Agenda item title: 83-89 Coventry St, Southbank - TP-2016-981 /A

Re. Response to Objection – 83-89 Coventry St, Southbank – TP-2016-981/A

Future Melbourne Committee Meeting No. 16, Tuesday 20 July 2021
Town Hall Commons, Ground Floor Melbourne Town Hall
Agenda Item 6.1 Planning Permit Application: TP-2016-981/A, 83-89 Coventry Street, Southbank

**Re: Future Melbourne Committee – Address to Councillors
Planning Permit Amendment Application TP-2016-981/A
83-89 Coventry Street, Southbank**

Figure: Czarny (Hansen) memo Coventry St section with notations added.

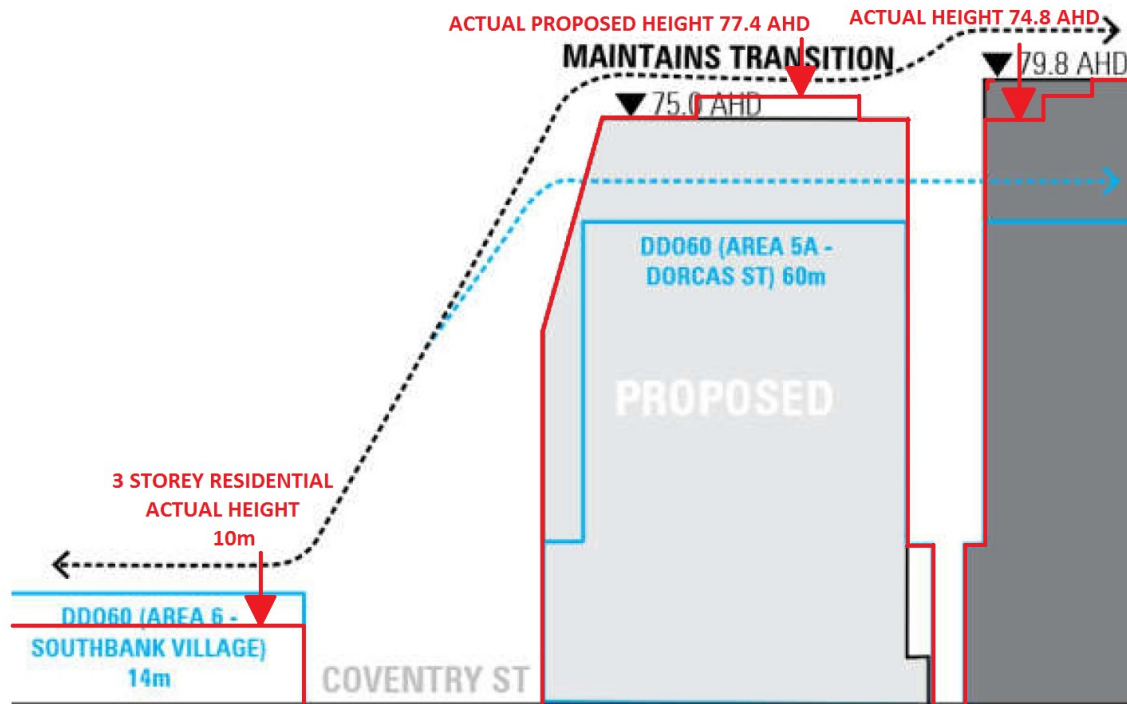
If the aim is to satisfy contextual suitability by consolidating a streetscape height, then the proposed building should be no higher than the 15 storey high Sunday Apartments at 65 Coventry Street. The mandatory Built Form Outcome for Area 5A in DDO60 Table 4 “requires the provision of an appropriate transition to development to the north of Area 5 (Coventry Street)”. This appropriate transition is clearly not achieved by the proposed increase in height to 73m (75.0 AHD) under the current proposal, which creates an abrupt sheer wall (very slightly tapered at its top) with inadequate setbacks, as demonstrated in the figure below:
